Special Permit #1665A S. 72nd & Van Dorn St.

Re: Van Dorn Meadows Addition - Amendment to
The Community Unit Plan
OA Project No. 2000-0607.05

To: Ray Hill, Planning Department
From: Charles W. Baker, Public Works and Utilities *BWB*
Subject: Van Dorn Meadows Special Permit # 1665A
Date: March 22, 2001
cc: Roger Figard, Nicole Fleck-Tooze

Special Permit #1665A
S. 72nd & Van Dorn St.
Proposed Plan

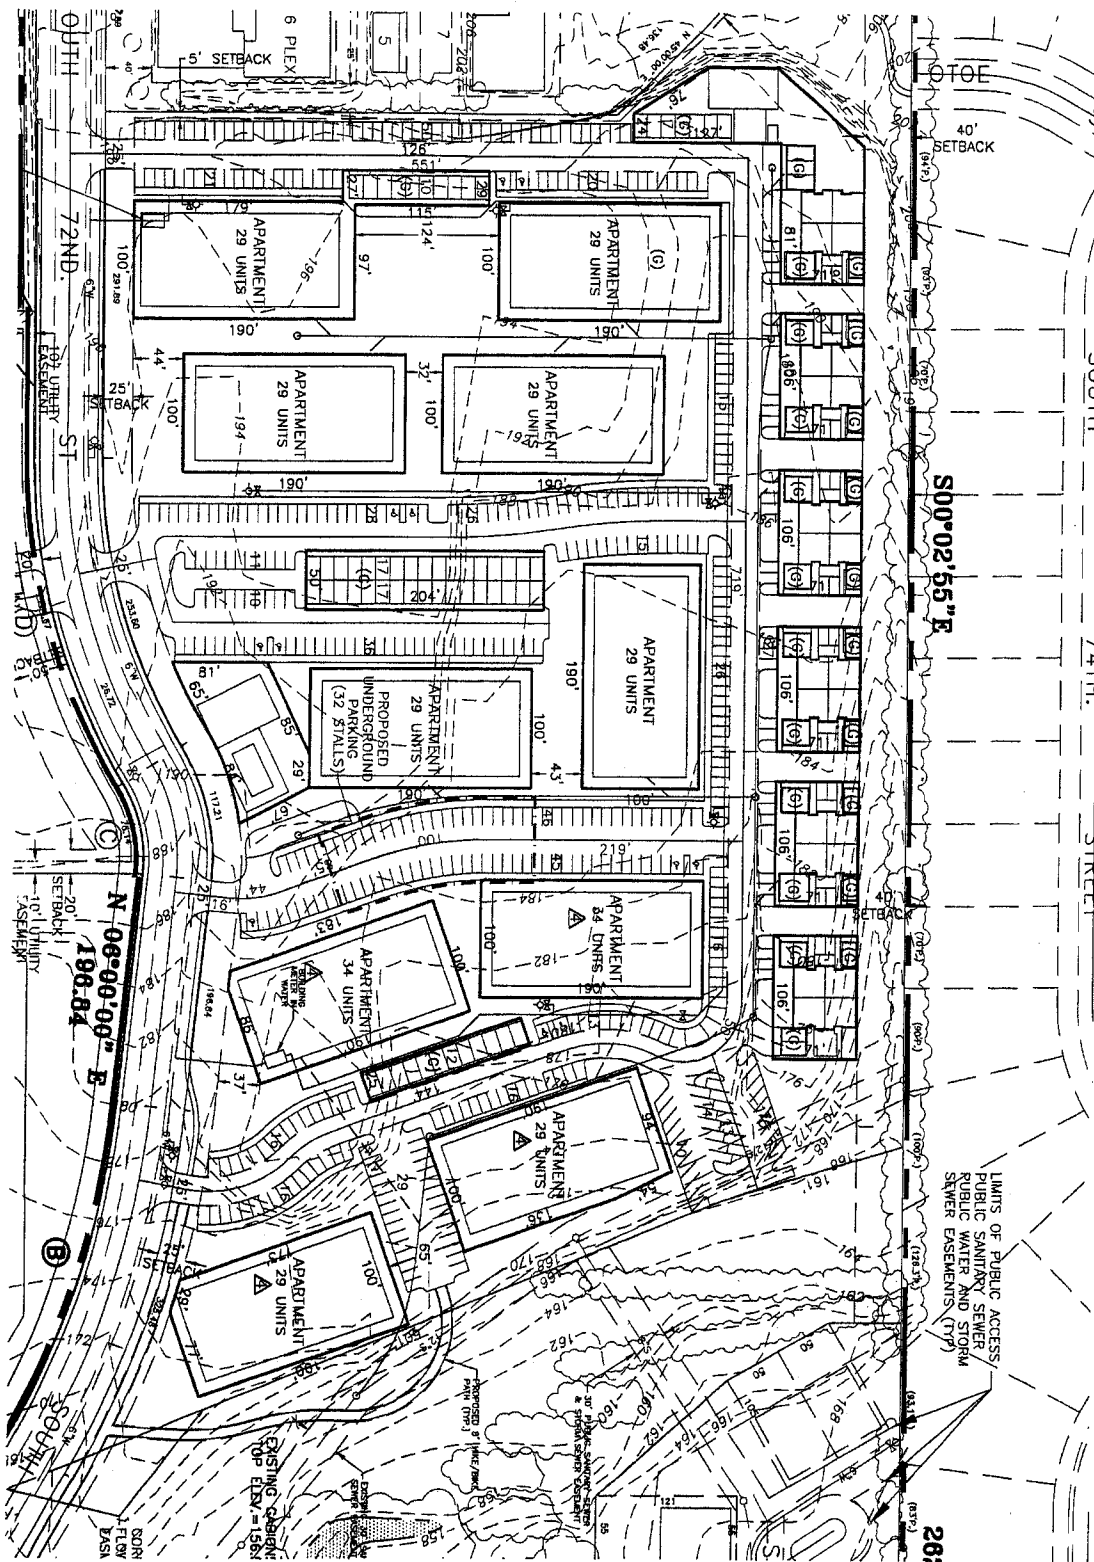
- 1.1 Revise the site plan to show:
 - 1.1.1 Corrected legal description to match boundary curve data
 - 1.1.2 Remove interior curve data because it is a driveway and not a private roadway.

- 1.1.3 Correct allowable density calculation to show 467 total allowable units.
 - 1.1.4 Correct spelling errors of "Acrea" to "Acres" in Density Calculations.

- 1.1.5 Expand 4-Plex detail to show driveways, serving the garages.
 - 1.1.6 Correct boundary data to match legal description.
 - 1.1.7 Show envelopes for ground signs on site plan or add note to plan that identifies that ground signs will be as allowed by the zoning ordinance.

- 1.1.8 Correct height in "Development Land Uses" table to show maximum allowable height of 35 feet.
 - 1.1.9 Add north arrow to vicinity map.
 - 1.1.10 Remove Planning Commission approval certificate and add City Council approval certificate.

- 1.1.11 Revise Note #17 to clearly show "Dwelling Unit, Type, and Location".
 - 1.1.12 Revise Note #11 to say "land area" instead of "existing plat".

1.1.13 Remove the typo "(G)" from the northeast apartment building.

1.1.14 Show the location of the dumpsters in an enclosure not in parking stalls of the parking lot.

1.1.16 Add a fence along the east side of all driveways serving the individual 4-plex garages.

Public Works requests that the proposed locations of the dumpsters be noted on the site plan for review. The note under Development Land Uses currently reads, "Subtract 12 spaces for dumpster locations in area". The dumpsters will need to be located in an enclosure not in parking stalls of the parking lot.

Special Permit #1665A
 S. 72nd & Van Dorn St.
 Proposed Landscape Plan

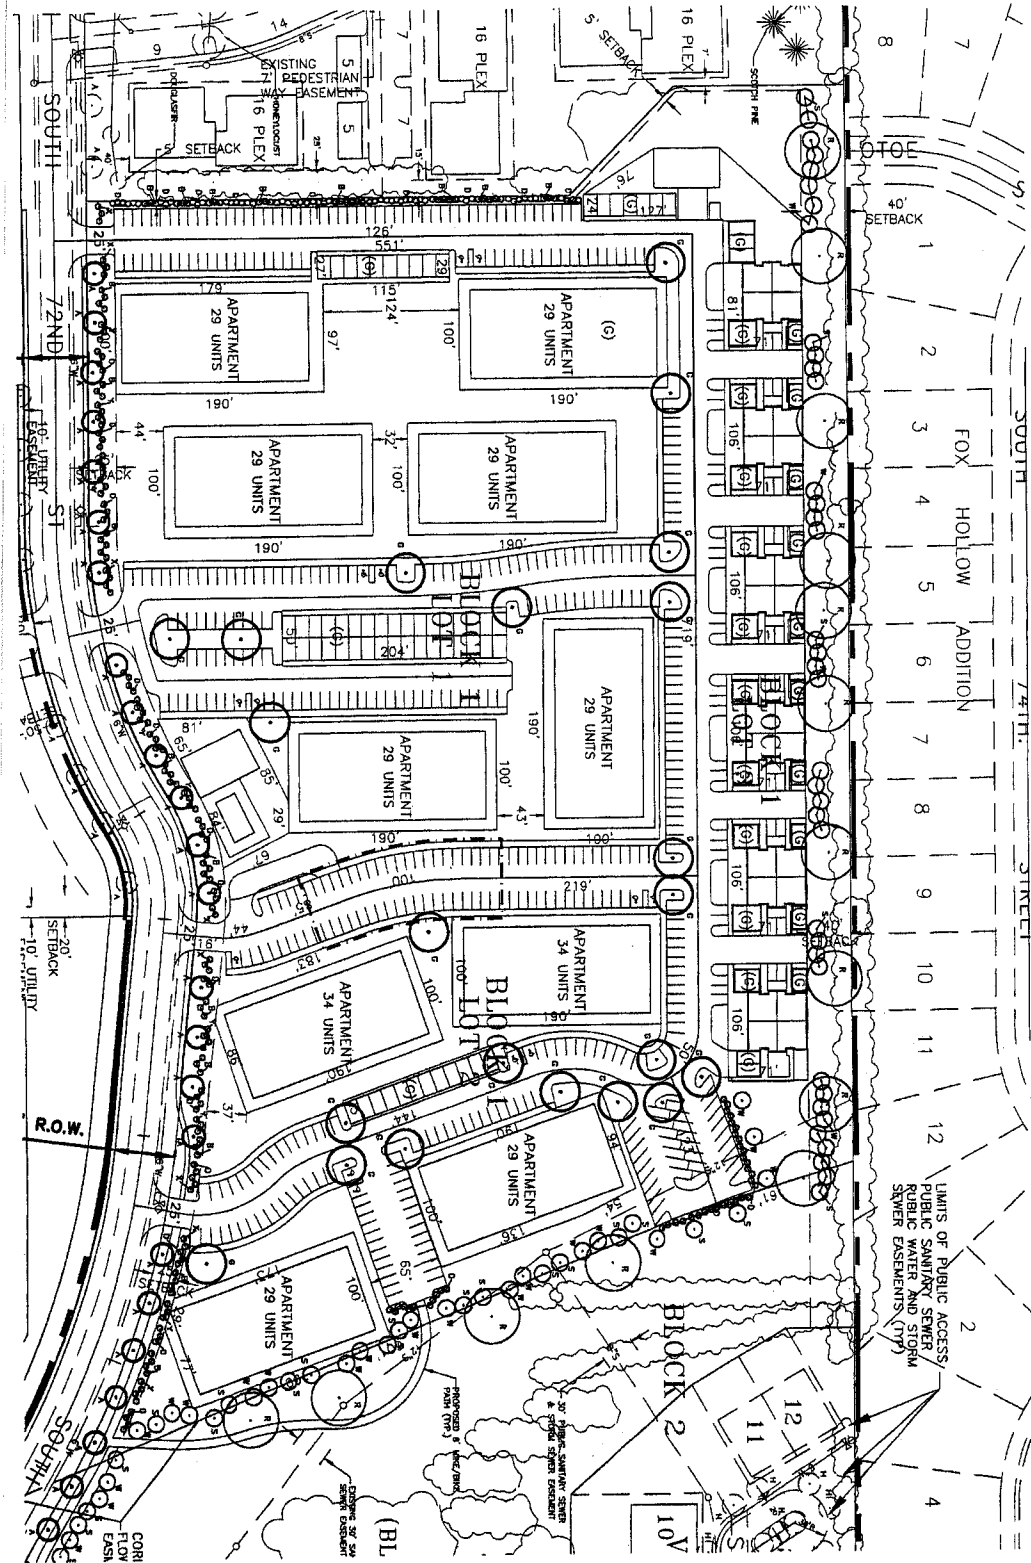
2.1.1 Remove references to administrative amendment on the landscape plan.

2.1.2 Note on the landscape plan that proposed street trees are to be located no closer than 5 feet from trail/sidewalk and shrubs no closer than 3 feet, and shall be planted on private property.

2.1.3 It is recommended that Scotch Pine not be planted due to Pine Wilt Disease. Substitute with Norway Spruce, Black Hills Spruce, or Limber Pine (Vanderwolf's Pyramid).

- 1) It needs to be noted on the landscape plan that proposed street trees are to be located no closer than 5 feet from trail/sidewalk and shrubs no closer than 3 feet, and shall be planted on private property.
- 2) It is recommended that Scotch Pine not be planted due to Pine Wilt Disease. Substitute with Norway Spruce, Black Hills Spruce, or Limber Pine ('Vanderwolf's Pyramid).
